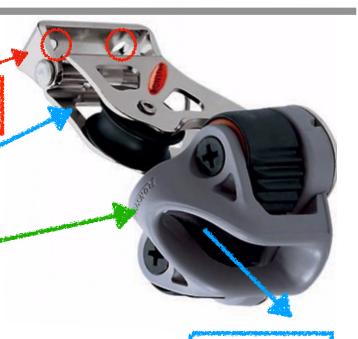
Old Clam cleat

Old Block

Attach under boom, need to rivet or tap 2 new screw hole #8

I removed the cam lead to allowing bring the outhaul forward for better leverage, then down to lock
